SR 40 PD&E Study

From Breakaway Trail to Williamson Boulevard

Final Location Hydraulic Report

Volusia County, Florida
Financial Project ID: 428947-1-22-01

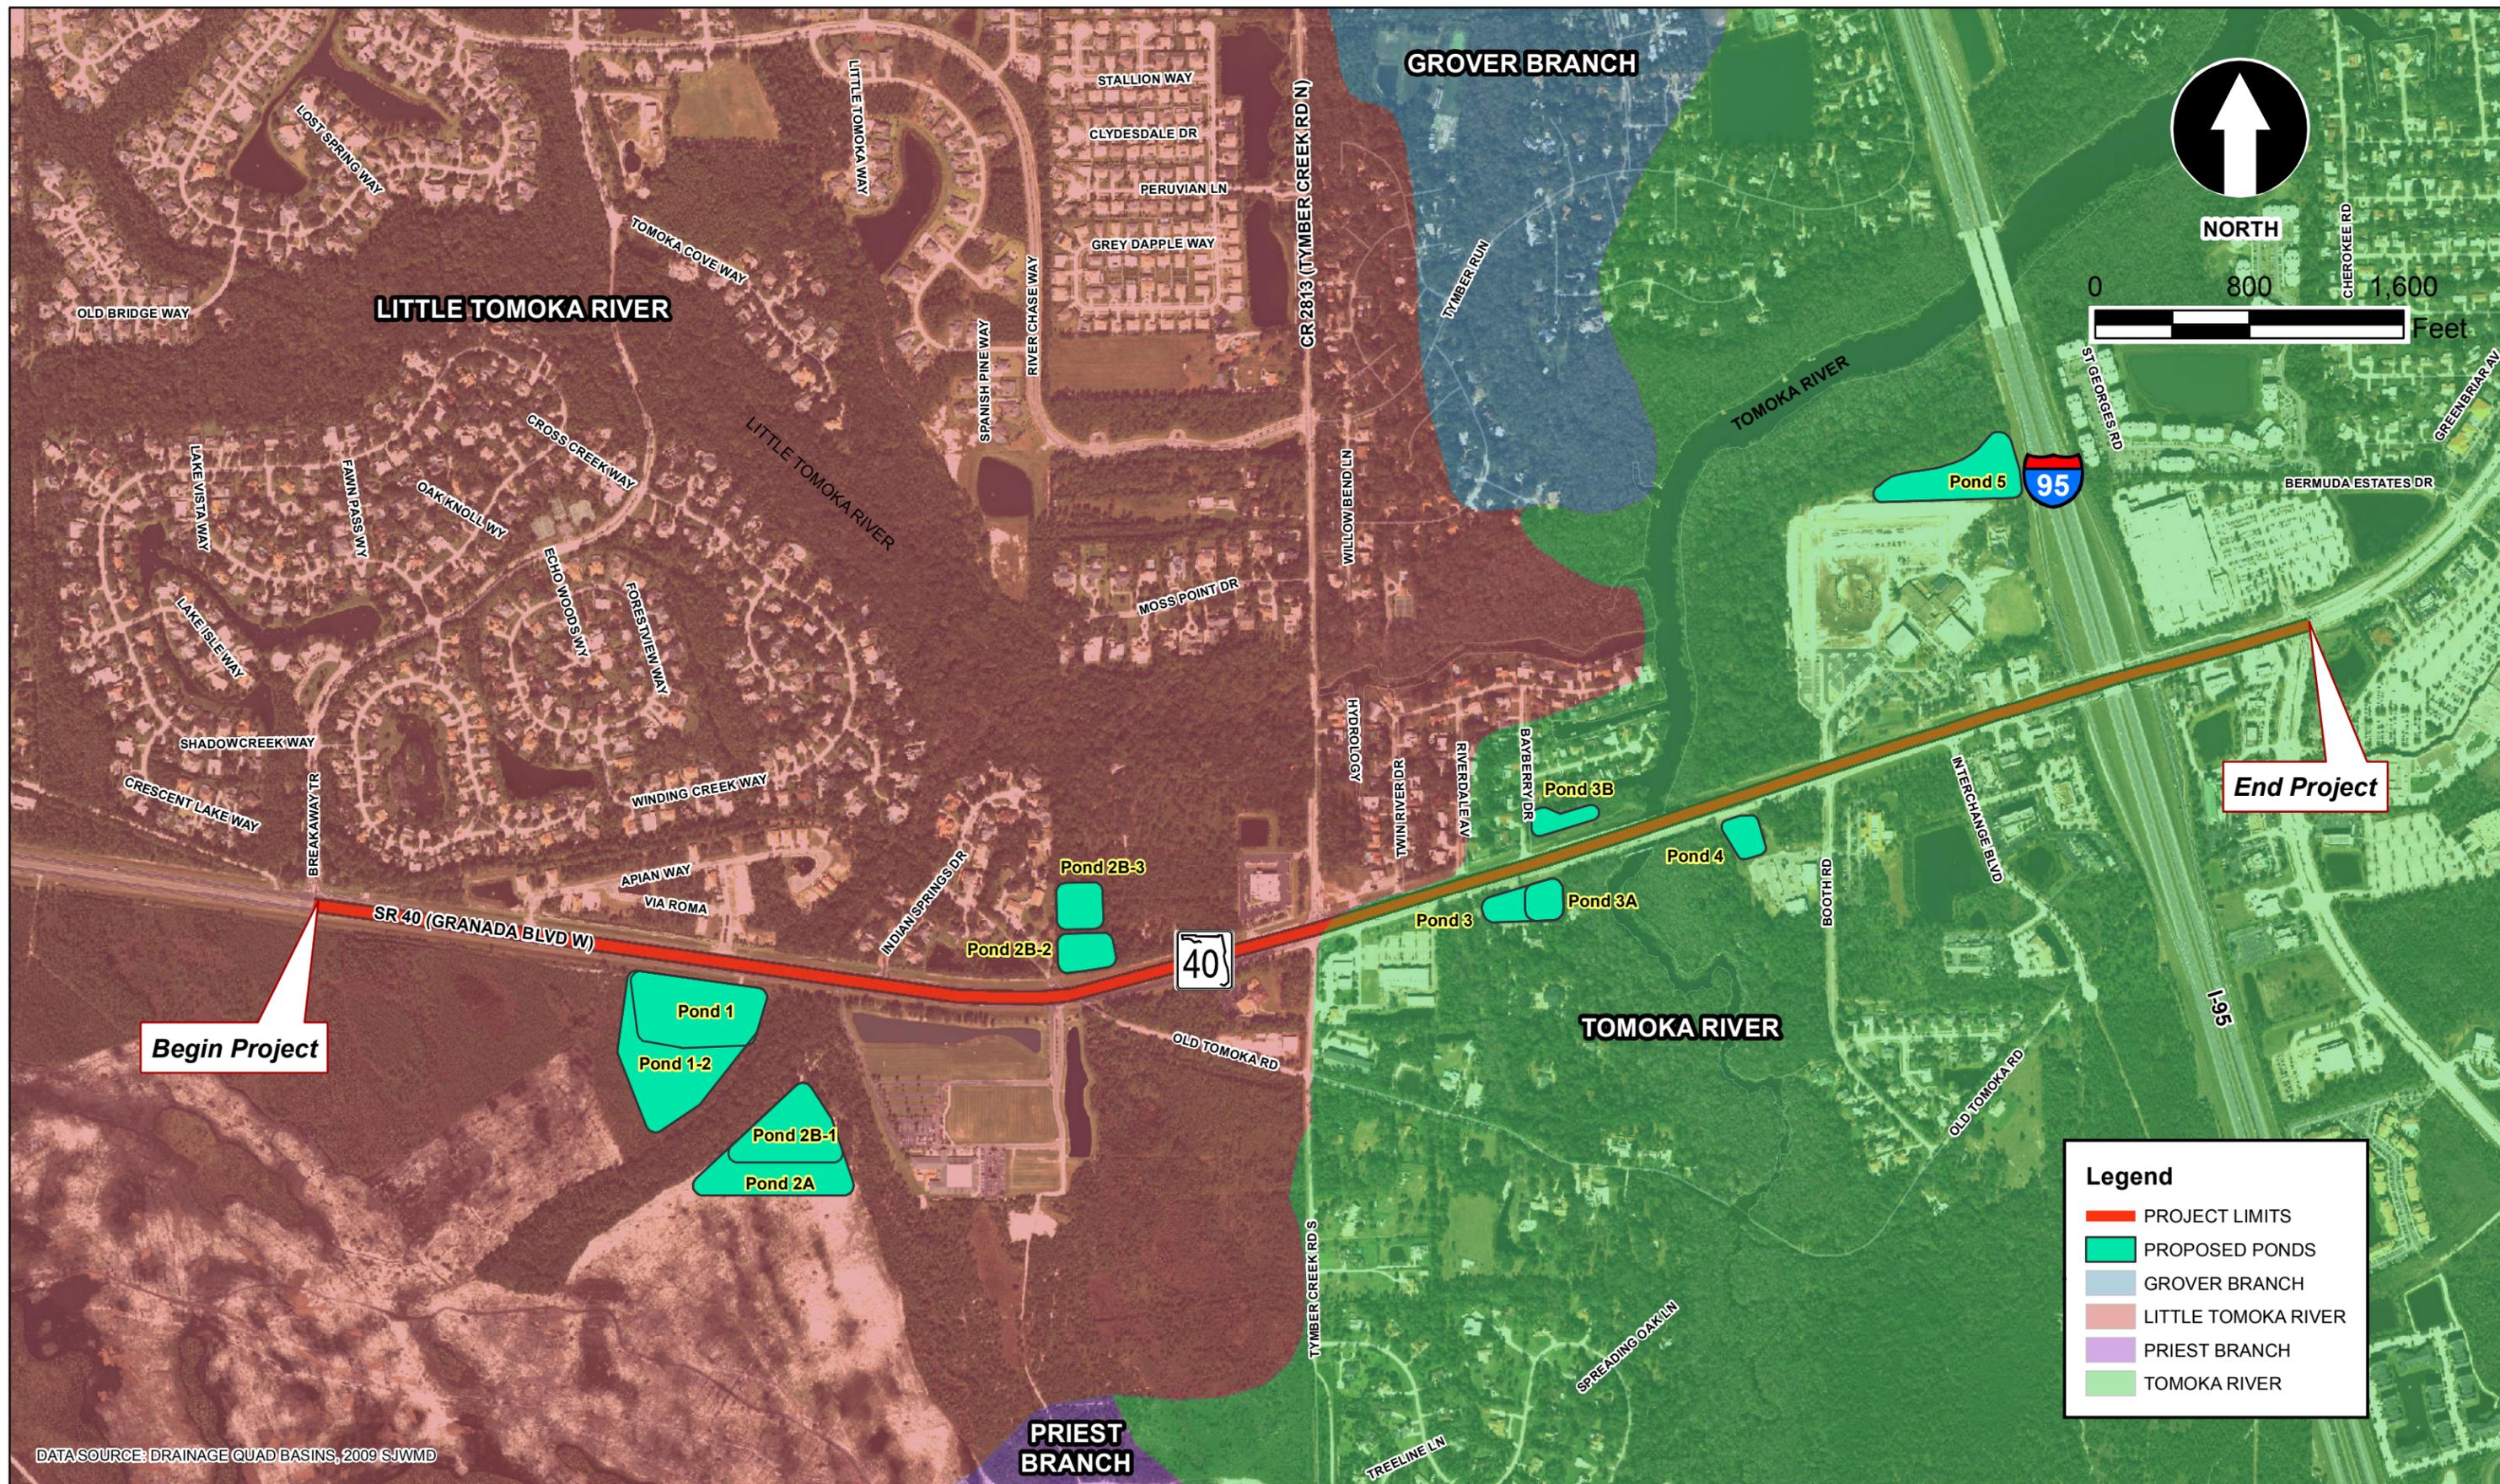
9. A map showing project, location and impacted floodplains. Provide copies of all applicable FIRM maps should be included within the final LHR report appendix.

Response: See SR 40 PD&E Location Hydraulic Report; Figure 7.

SHEET NO.
 7

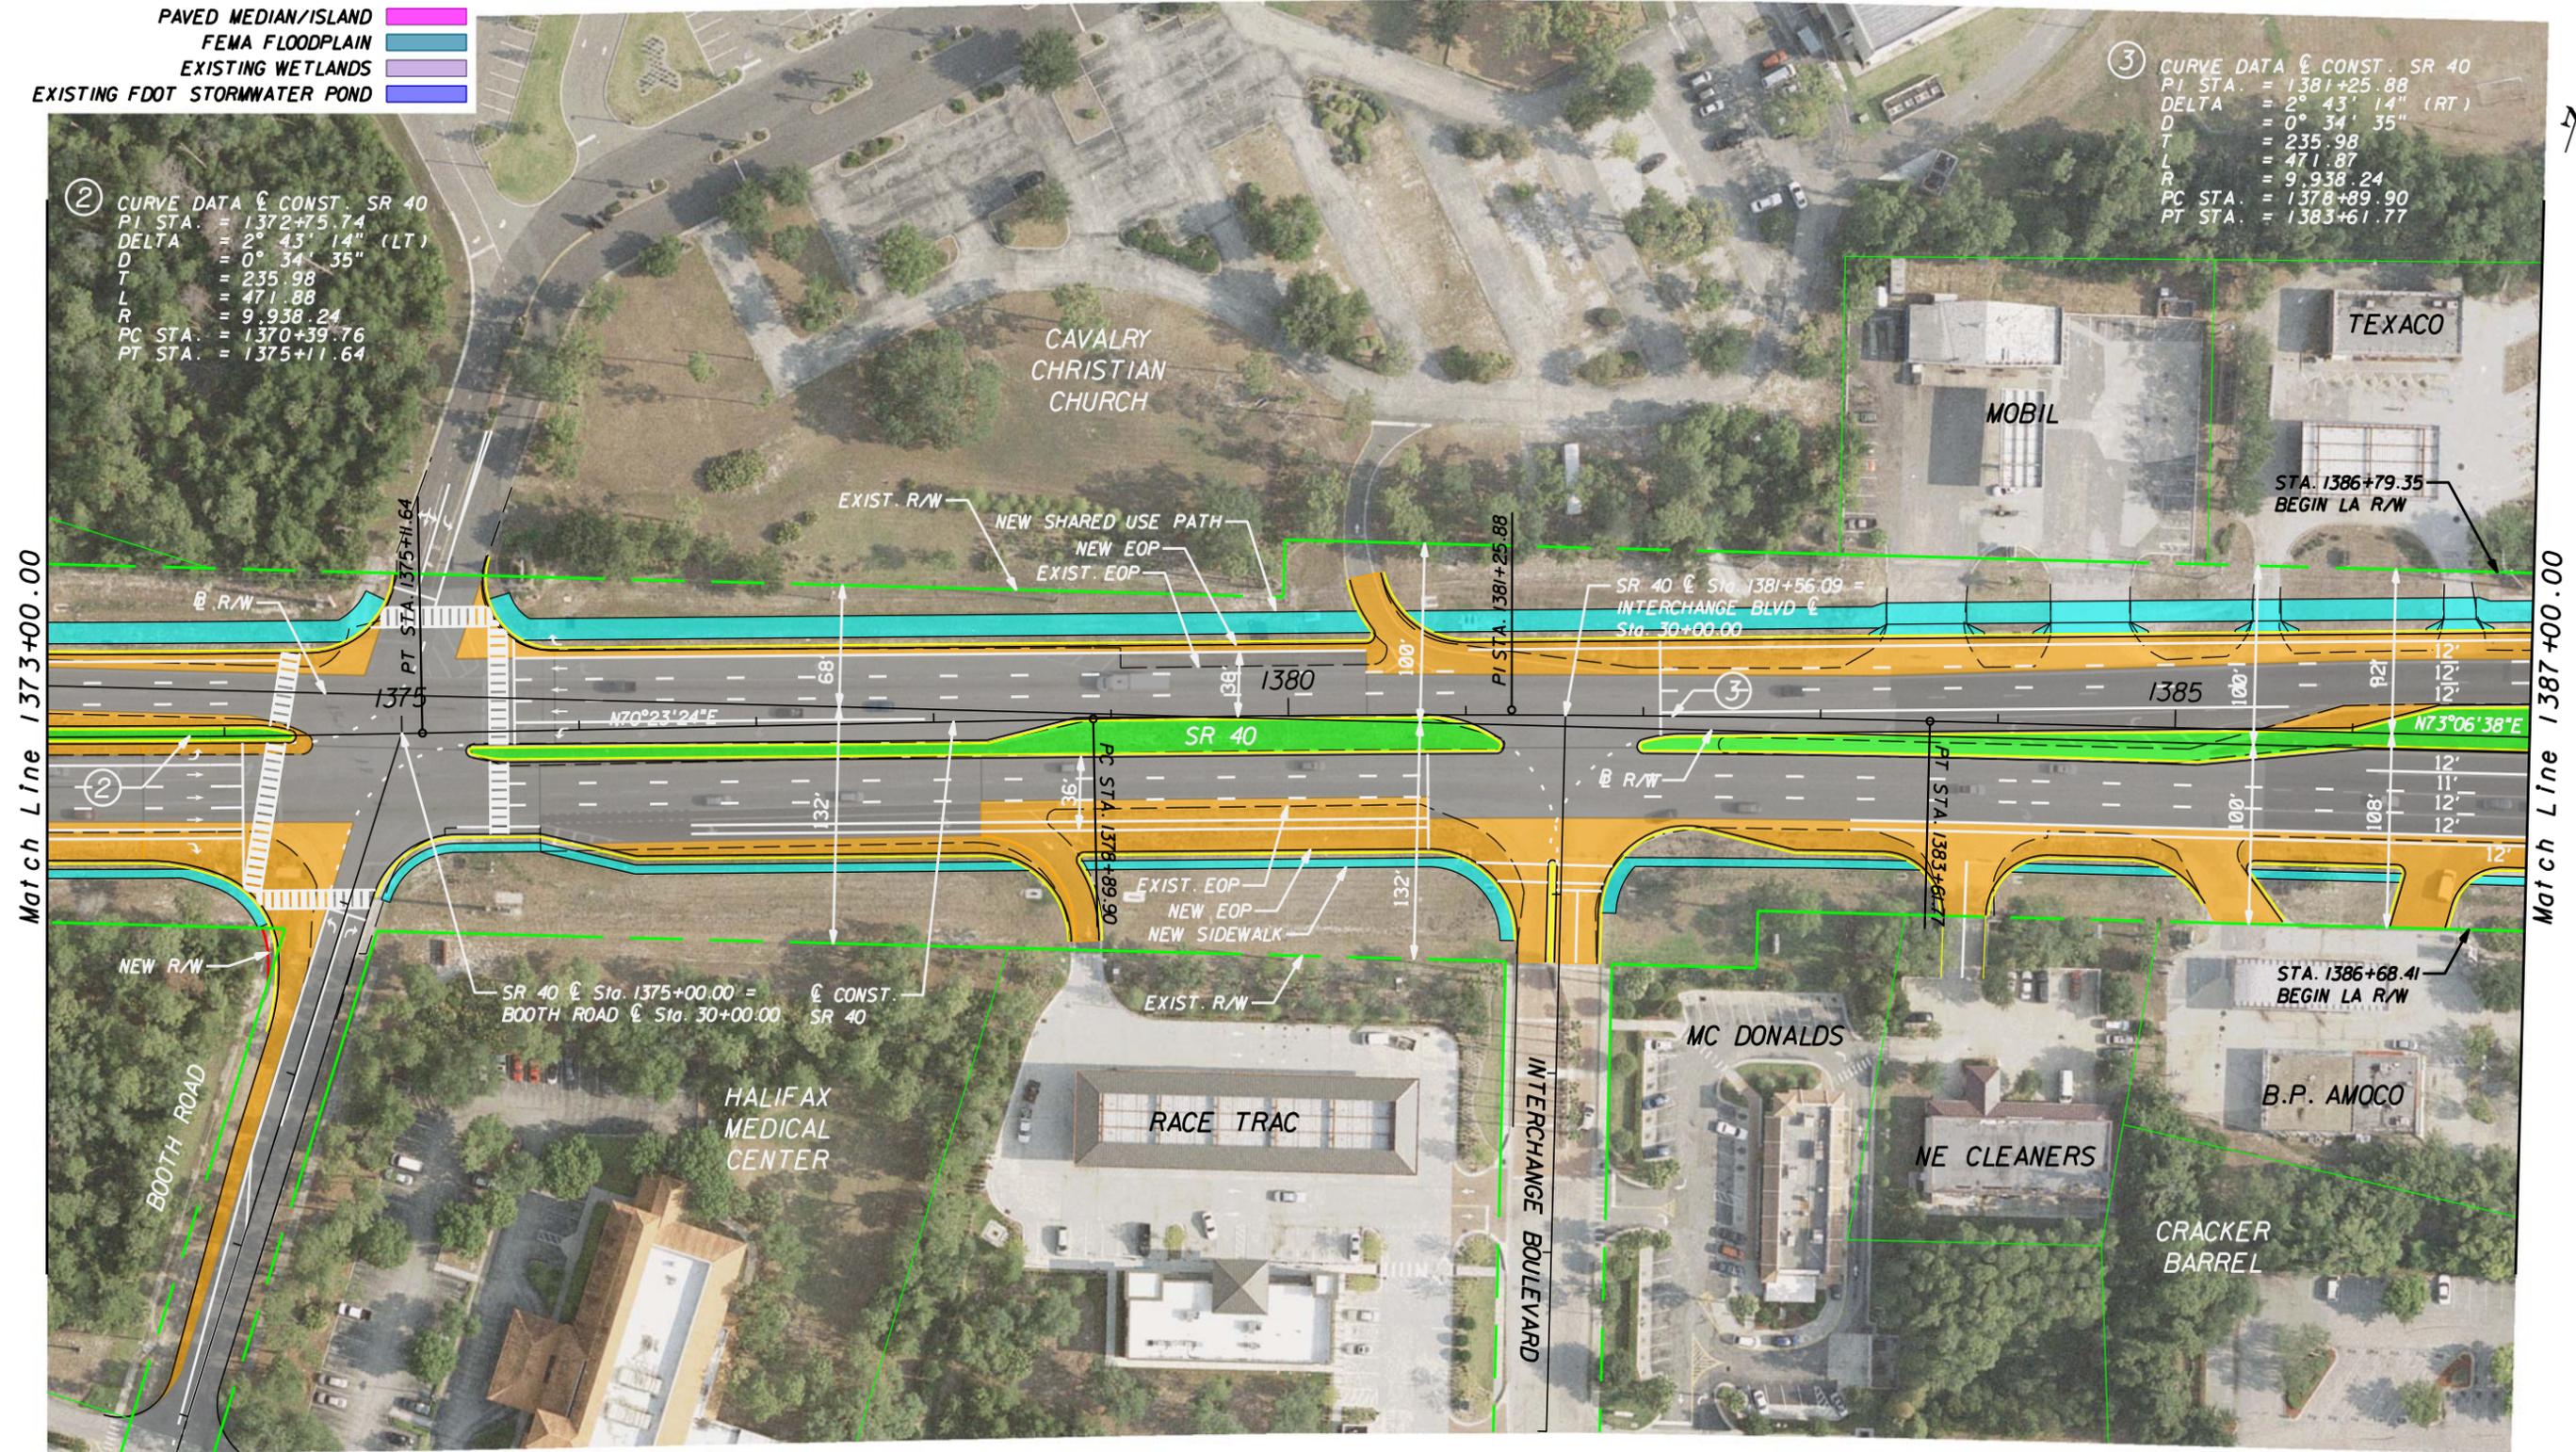
Sheet #7 – It was discussed that the property in the northwest side of the Tomoka River bridge is currently used for a canoe launch. During project meetings, questions have been asked whether a park can be provided at this location for public access to the river. This property is shown on the Volusia County Property Appraiser's website to be privately owned.
